RS-21-040

LaSalle County Station, Units 1 and 2
Renewed Facility Operating License Nos. NPF-11 and NPF-18
NRC Docket Nos. 50-373 and 50-374

Subject: Response to Second Round Request for Additional Information (RAIs) for LaSalle License Amendment Request to Adopt Risk Informed Completion Times TSTF-505, Revision 2, "Provide Risk-Informed Extended Completion Times - RITSTF Initiative 4b"

Response to Request for Additional Information

Figure 1 - Initial electric plant line-up following a DLOOP with a LOCA on Unit 1 and Unit 2 'A' EDG out of service

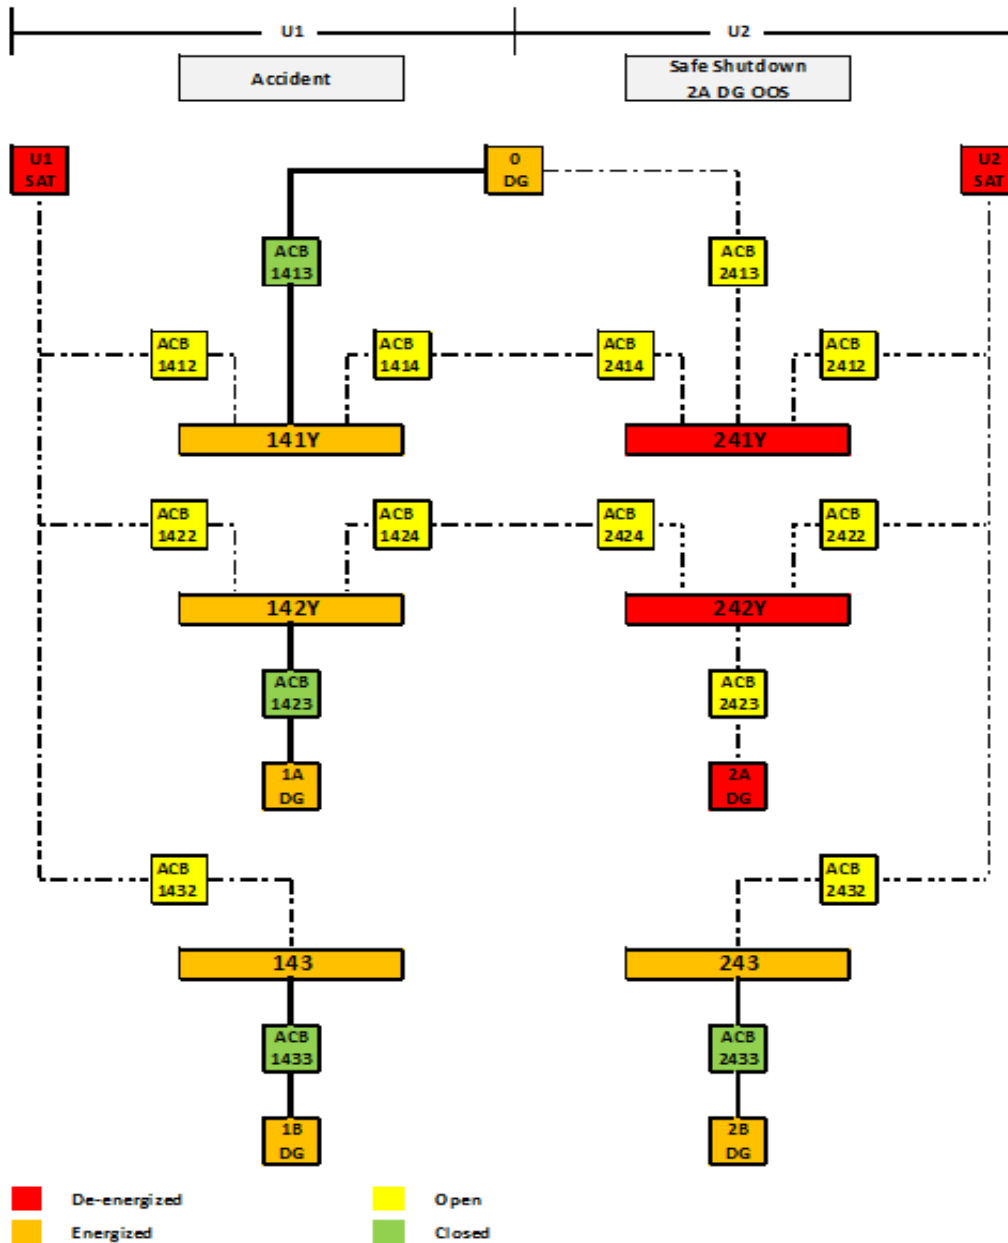
RAI-R2 EEEB 1: By letter dated October 1, 2020, Exelon's response to EEOB TSTF-505 RAI No. 1, "Technical Specifications Associated with TS 3.8 'Electrical Power Systems impact on Non-accident Unit'," indicates the use of site procedure LOA-AP-101, "Unit 1, AC Power System Abnormal". For the same scenario specified in the September 3, 2020, staff RAI, please provide the following:

Details of any additional defense-in-depth capabilities at LaSalle, in line with stated criteria above, that would allow for a controlled, safe shutdown of the non-accident unit. This pertains to the requested changes to TS 3.8.1.B, TS 3.8.1.C, and TS 3.8.1.E for the Division 2 DGs.

Figure 1 represents the initial electric plant line-up following a DLOOP (Dual Unit Loss of Off-Site Power) with a LOCA on Unit 1 and the Unit 2 'A' EDG out of service.

The postulated scenario results in a Station Blackout (SBO) on Unit 2. LSCS SBO coping method uses Reactor Core Isolation Cooling (RCIC) or High Pressure Core Spray (HPCS) to provide makeup water for core cooling. The HPCS system normally takes suction from the suppression pool, and RCIC suction automatically transfers to the

Figure 4 – 125 VDC Subsystem Drawing

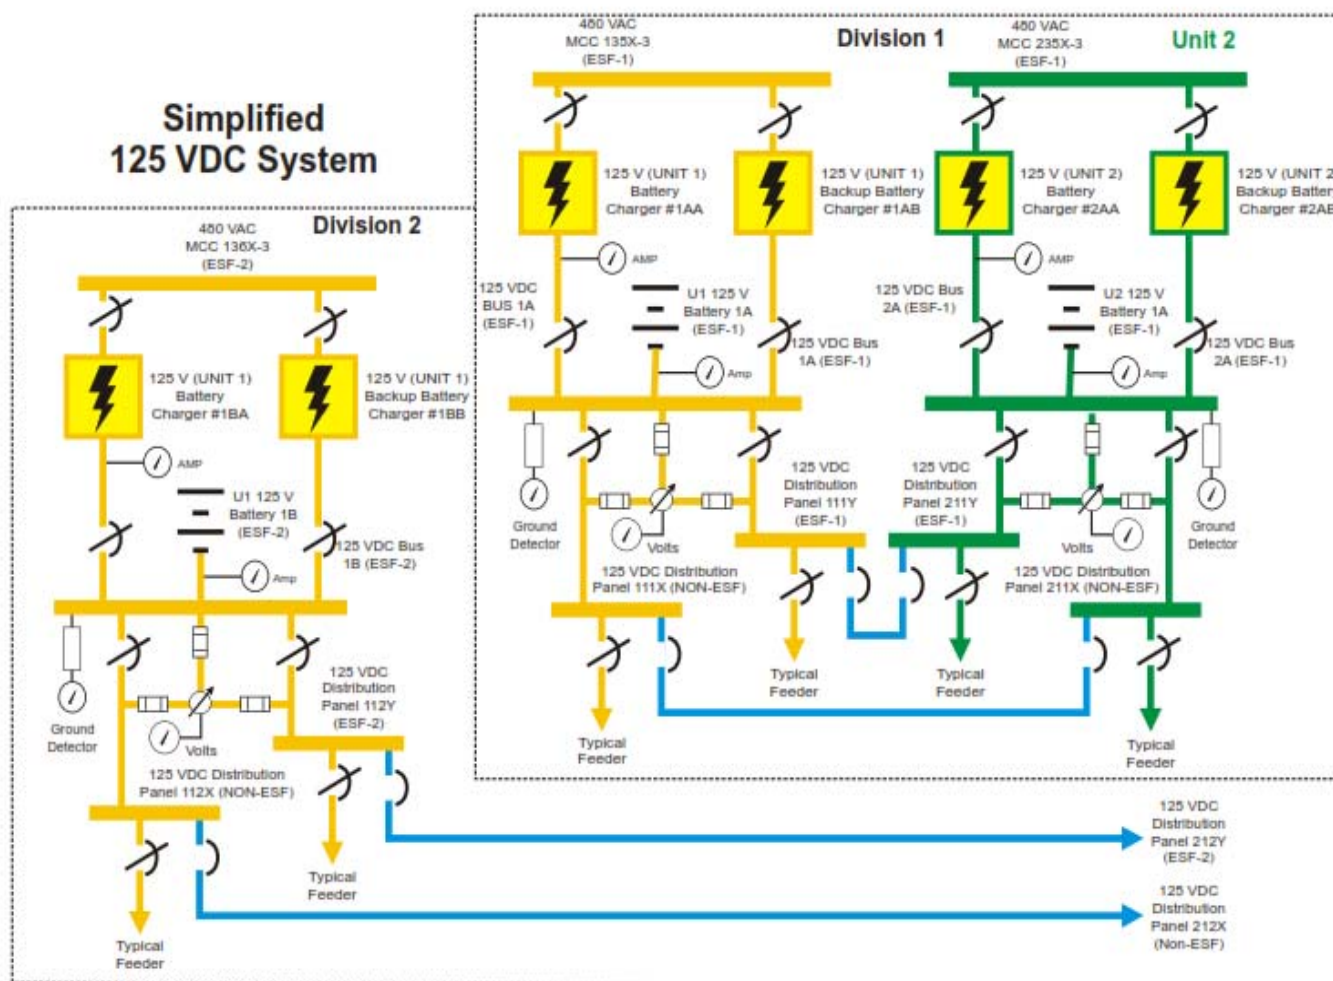
RAI-R2 EEEB 2: For the conditions postulated in Table E1-1, please clarify if procedure LOA-AP-101, "Unit 1, AC Power System Abnormal," would be implemented for the safe shutdown of the non-accident unit under the same conditions specified in RAI EEEB 1 above, including the requested information for defense-in-depth capabilities, when the indicated Division 2 SSC is in a RICT for the following TSs:

TS 3.8.4.A – 125 VDC battery charger

To aid in understanding equipment line-ups, and power sources, Figure 4 is provided for the 125 VDC power subsystems.

Both Units at LSCS are designed with (2) fully qualified battery chargers for the 125 VDC Division 1 and Division 2 electrical power subsystems. Only 1 battery charger per division is online at any given time except when swapping battery chargers from primary to backup. Maintenance is performed periodically on the alternate (offline) battery charger. Scheduled maintenance is not performed on both the alternate and required battery chargers at the same time.

In the event of a failure of the online (required) battery charger, the alternate (offline) battery charger would be placed online per LOA-DC-101(201), "Unit 1(2) DC Power System Failure," Section B.1, "Loss of a Battery Charger."
